Response to CHRSA letter, “Response for Stop Work Order”

August 27, 2018

RE: CHSRA DID NOT DESIGN SAFE AND RELIABLE HIGH-SPEED RAIL CURVES NEAR THE SAN JOAQUIN RIVER. THIS IS A SECOND REQUEST FOR IMMEDIATE STOP WORK ORDER FOR MERCED TO FRESNO SECTION.

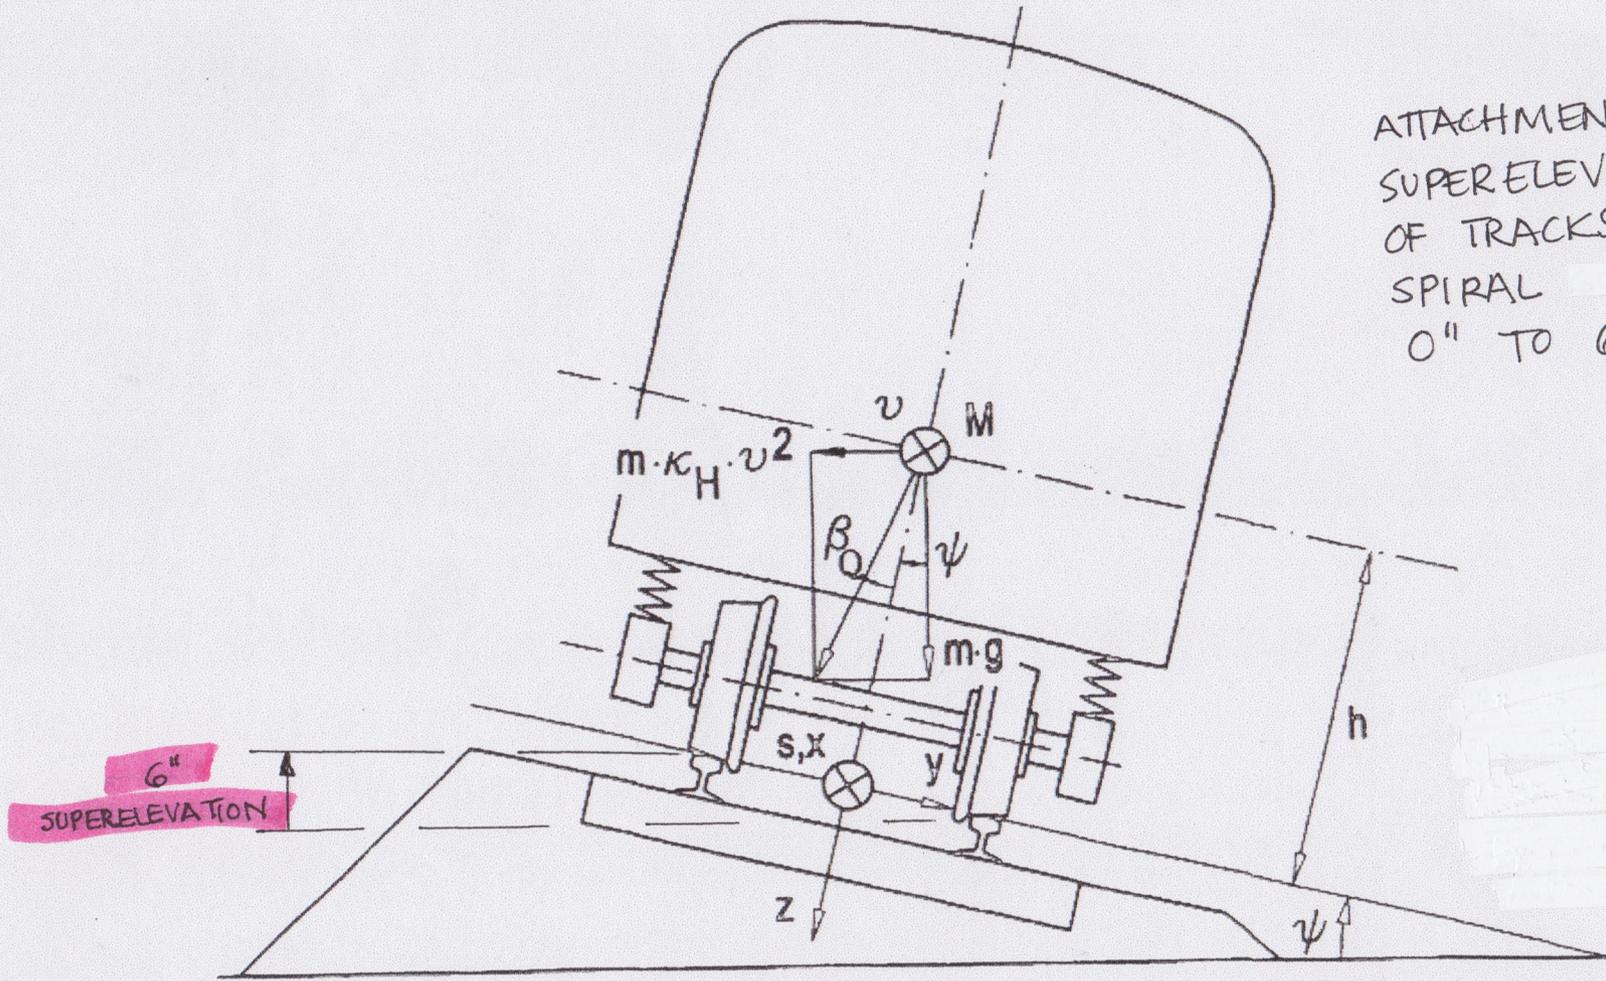
Speeds between 60-90 mph do not pose a threat of derailment, but the passengers will feel a great deal of discomfort and a sense of vertigo at the same location where the faster vehicles would derail. The slower speeds will tilt the vehicle too much on one side where the vertical curve begins descending. As a result, cell phones would slip from the tray table. Crash. Then the laptops would cascade onto the floor,

followed by the cups of coffee. All of these items will collect on the corner on the right-hand side of the vehicle. Passengers will never ride the train again.

ATTACHMENT 3
HSR STRUCTURE NEAR
SAN JOAQUIN RIVER,
TRACK TO BE BUILT
ON TOP OF ELEVATED
STRUCTURE

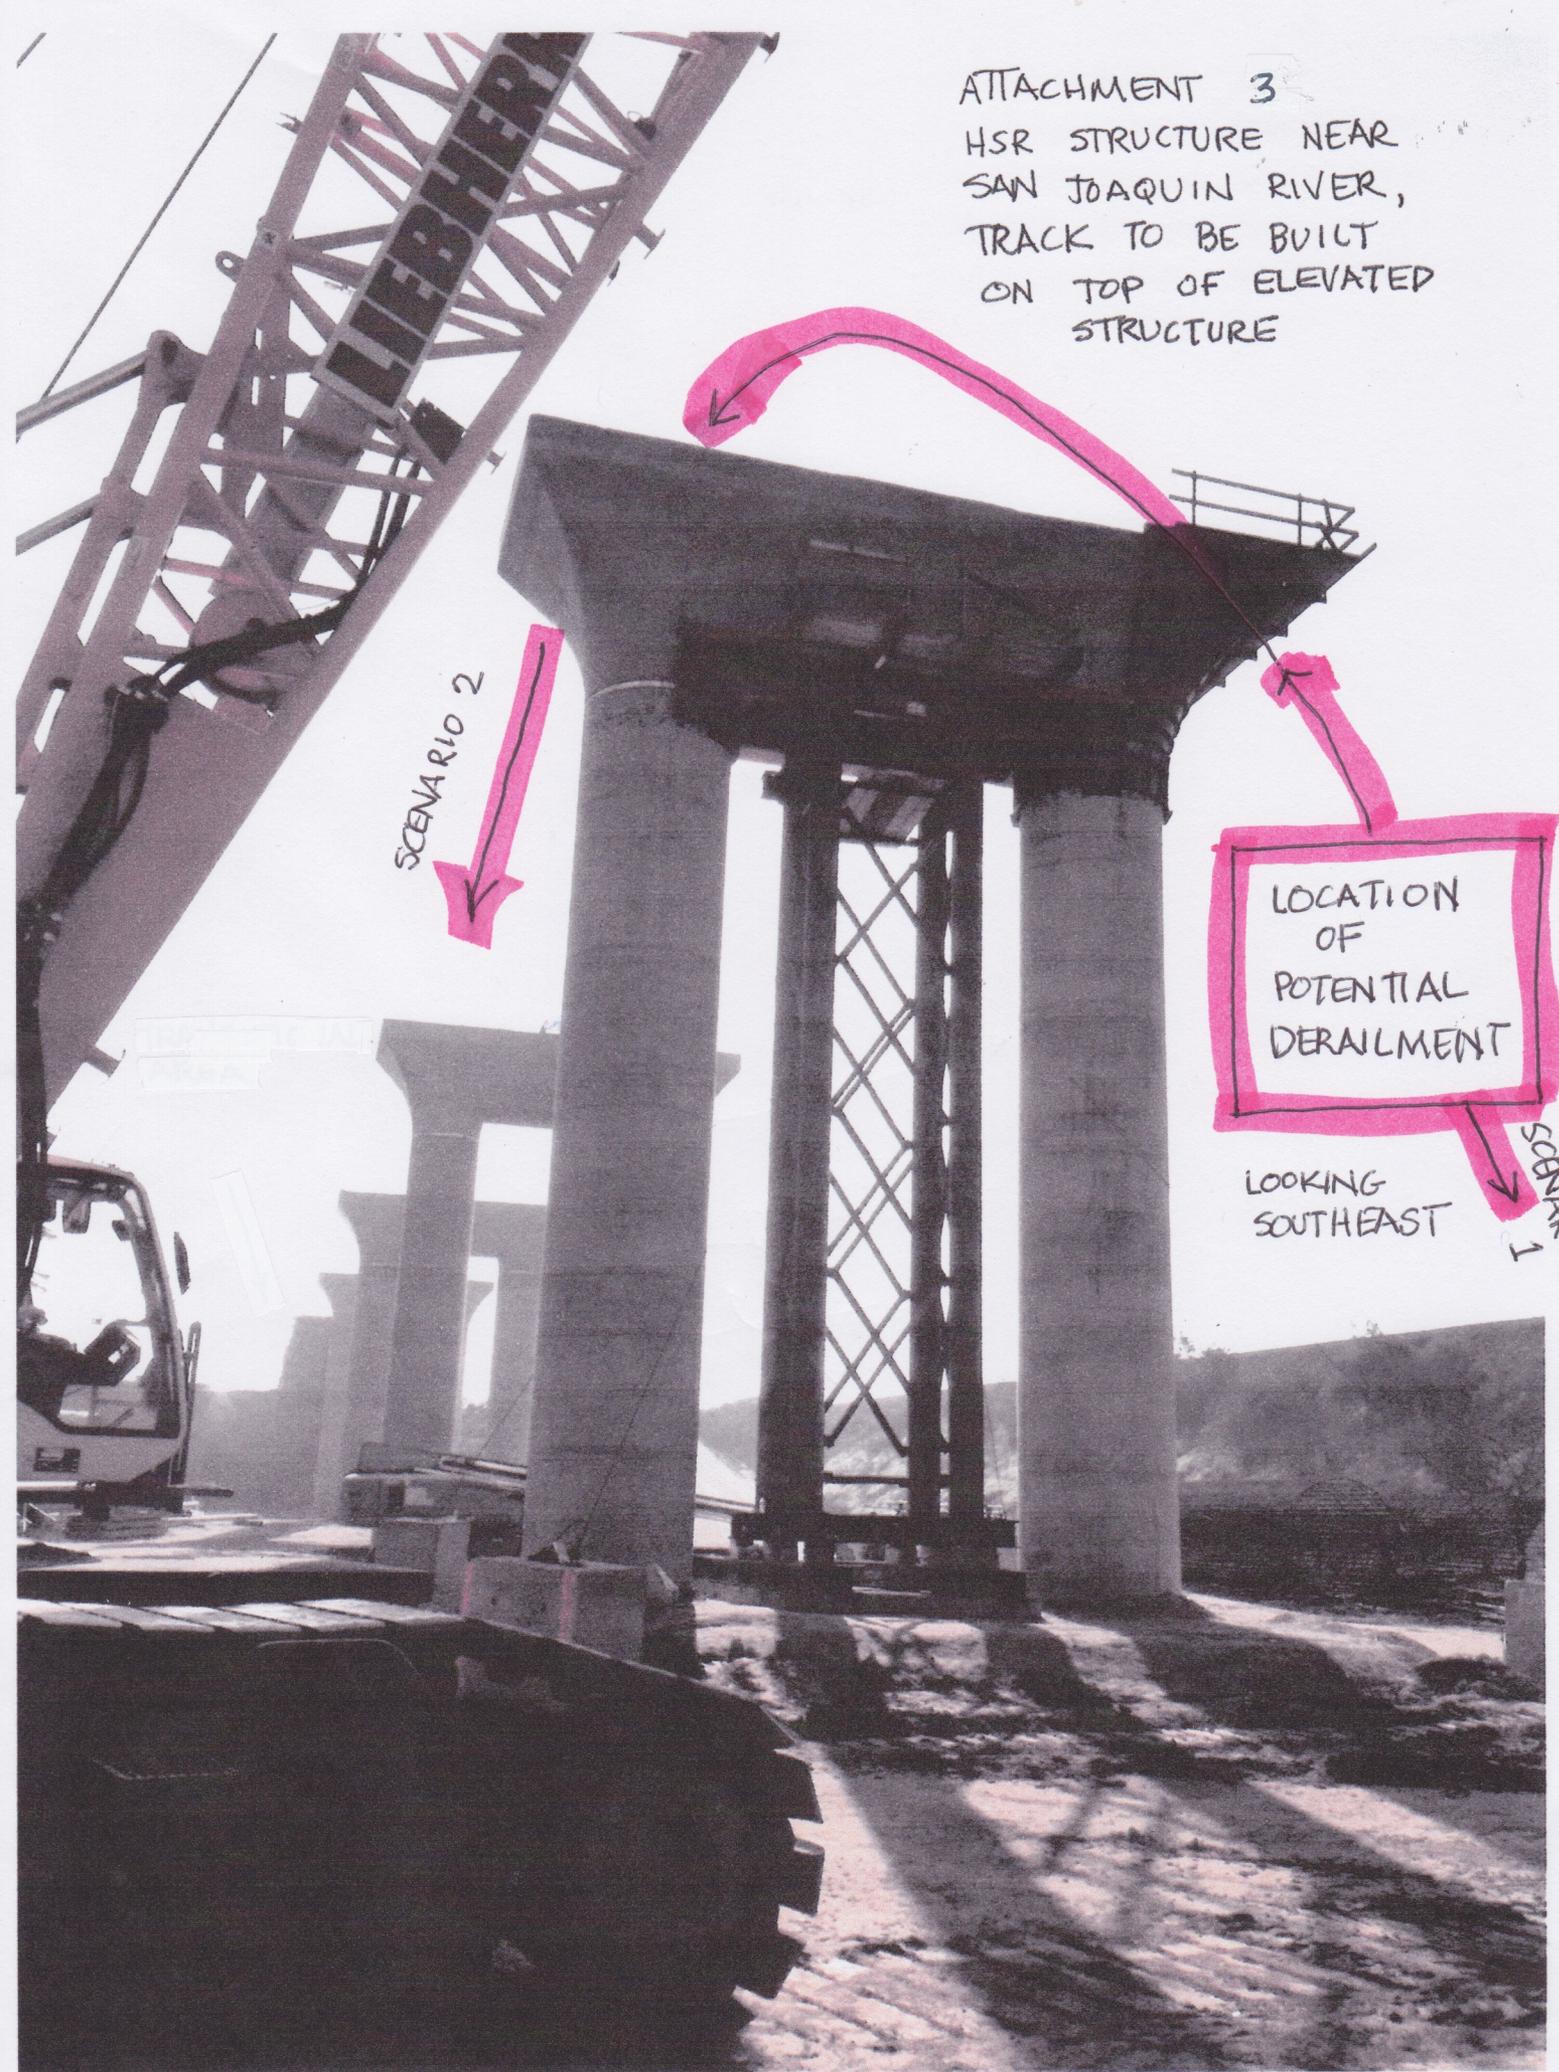
North of Herndon Drive in Fresno, the northbound train travels on top of sixty to one-hundred-foot structures. See Attachment 3, HSR Structure near the San Joaquin River. Using the northbound train in this example, the train enters a vertical curve, where the tracks rise up slightly, then descends at a more rapid rate. As the train enters this vertical rise, a horizontal spiral is introduced, the tracks start to curve to the right and the track begins to super-elevate. The outside left rail eventually rises six inches more

Then the vertical curve descends, goes downwards, and the left side of the train, the outside flange of the wheel, is still climbing the rail to accommodate for the centrifugal forces. When the rail begins its descent down the vertical curve, the left side of the train keeps rising off the top of the rail.

Imagine the jet airliner that reaches critical take-off speed and the runway slowly drops away beneath the plane and the airliner becomes airborne. The same thing will happen in this curve. The train will take flight from the structure and travel straight forward like a speeding bullet. The vehicle also begins to twist, the left side still rising, because what is set in motion, continues to stay in motion. In an eight vehicle train, the first three vehicles fly over the southbound track as the head vehicle, the HSR signature locomotive, takes out a string of catenary poles and wires. Gravity begins to take over and pull each vehicle downwards. The middle vehicle hits the southbound bridge deck sideways and get sheared in half, longitudinally. The last three vehicles jack knife behind the middle vehicle and travel like shrapnel in all directions, potentially landing on top of Highway 99, which runs parallel and adjacent to the UPRR tracks. The greatest damage could be caused by the first vehicles that fall in-between the two sets of support structures: the UPRR bridge over the San Joaquin, and the HSR structures. Both sets of infrastructure could be critically damaged by the derailed vehicles that could hit the bridge abutments at the speed of a missile. The front vehicle, now encased in catenary poles and wires, may continue straight forward until it collides with the 80 foot embankment of the San Joaquin River, crush like a soda can and compress inside a tangled web of catenary poles and wires, collapse down the hillside and fall into the river and sink. Safety personnel are unable to reach the site because of all the adjacent critical infrastructure is shut down. There are no survivors.

In response to my original report, several engineers stated that the trains would go slower through this curve. Let's look at that. When the trains travel between 90-150 mph, the same scenario applies. Only this time, the trains will not fly from the bridge deck like missiles. The vehicles will leave the track in the same location as Scenario 1, but instead of becoming airborne, start to lift off the rails, derailing one by one, each vehicle twisting clockwise to the right. The vehicles will tumble off the bridge deck, 60 to 100 feet, potentially continuing to rotate through the air and land upside-down. Other passenger vehicles will crash on top of the first. No survivors.

SCENARIO 2

LOCATION
OF
POTENTIAL
DERAILMENT
